Operation Inspection Report
for
Department of Energy

Date of Inspection September 21, 1994

Dam Name Dams A-4, B-5 & C-2

Department of Energy (Facility Name) Rocky Flats

1994 Elevations of Pond C-2 and Piezometers

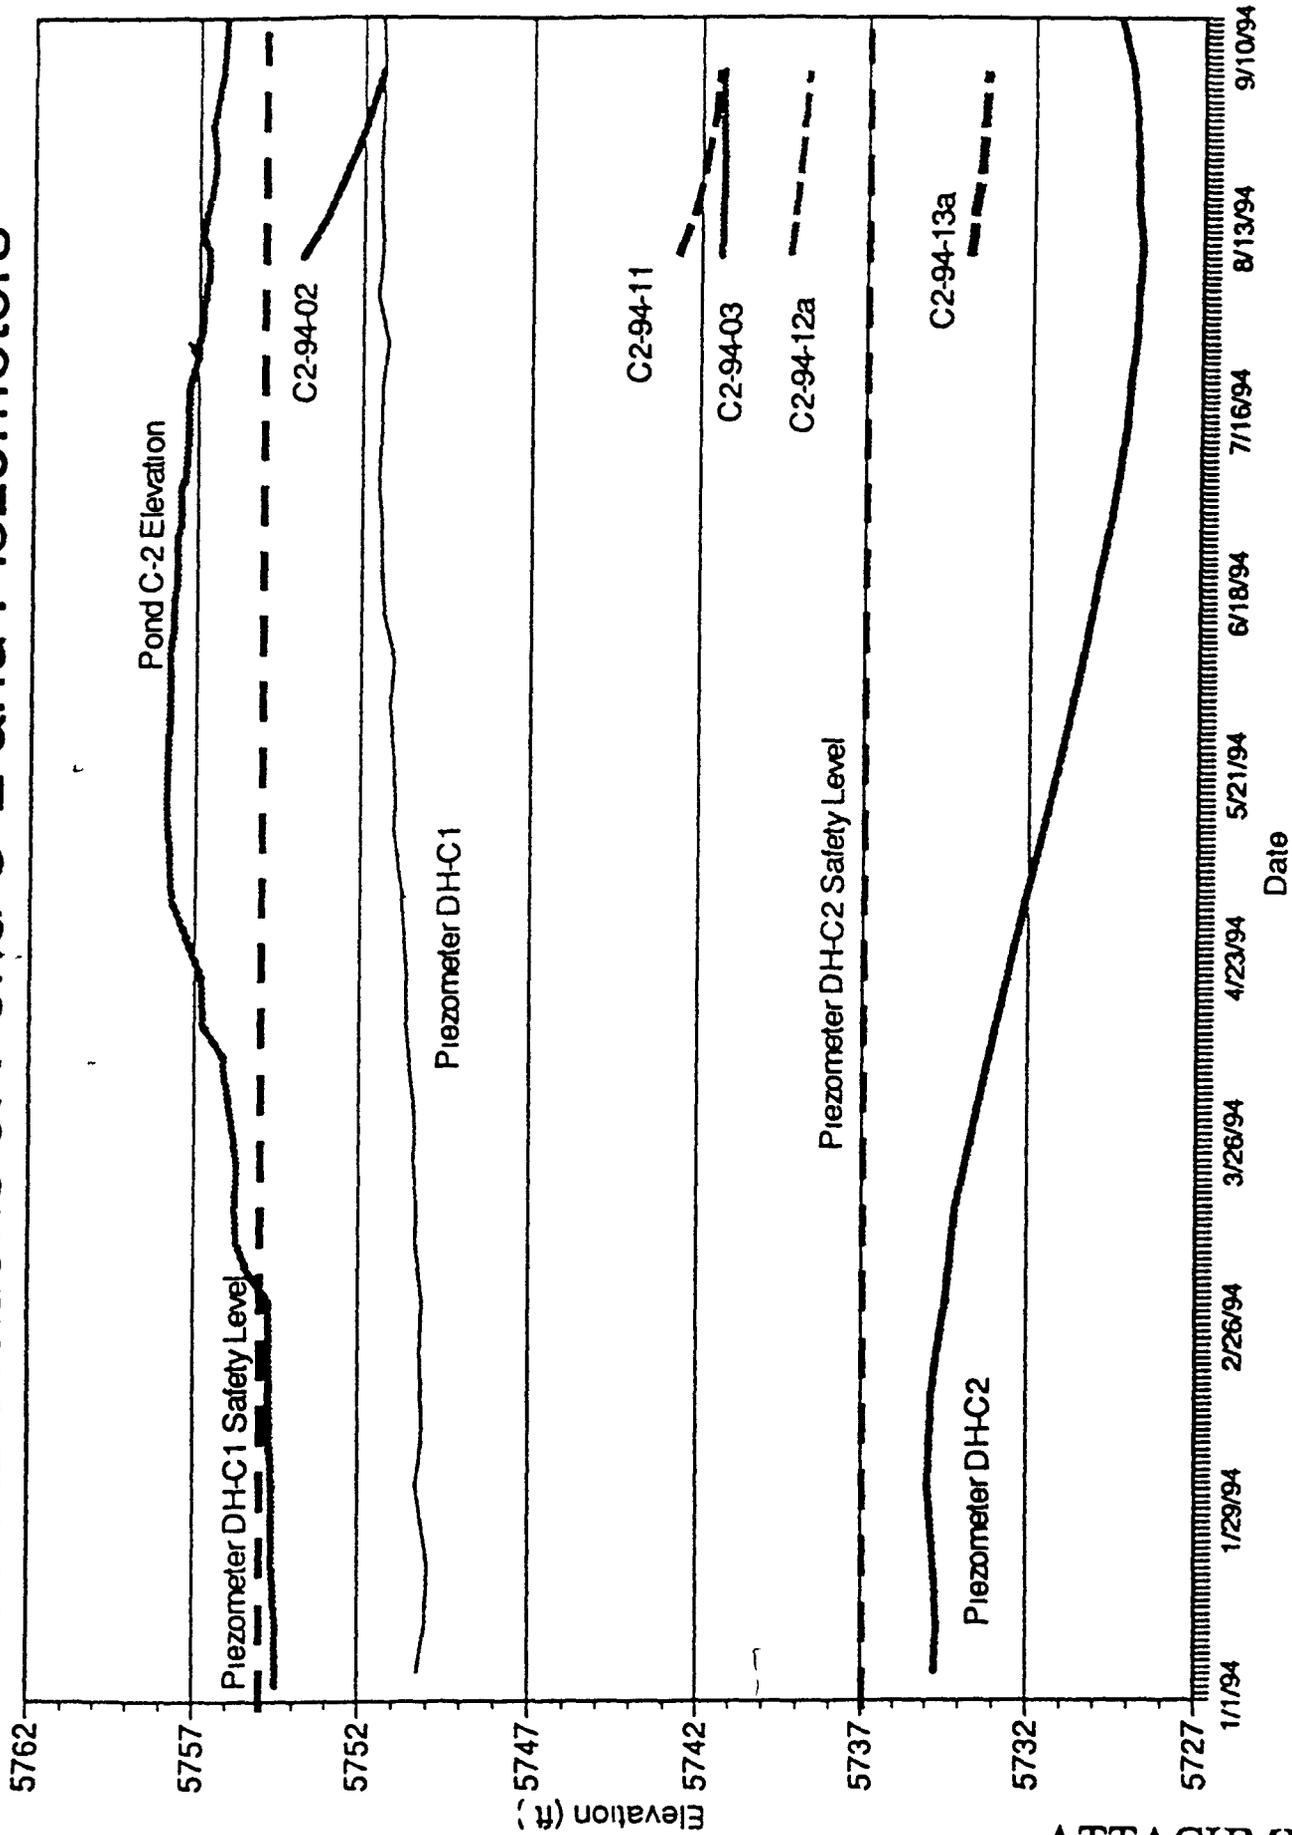
Dam C-2 Five additional piezometers were installed during June, 1994. Two of them, C2-94-02 and C2-94-03 are at the crest and the other three, C2-94-11, C2-94-12a, and C2-94-13a are at the toe of the dam. A view of the telemetry system at C-2 is seen in photo 25. The readings for these piezometers appear to be following the reservoir level in the dam, though more data will be required to arrive at any conclusions.

The reservoir levels for Dam C-2, have also been higher than originally intended. The highest elevation has been as high as 33% full.
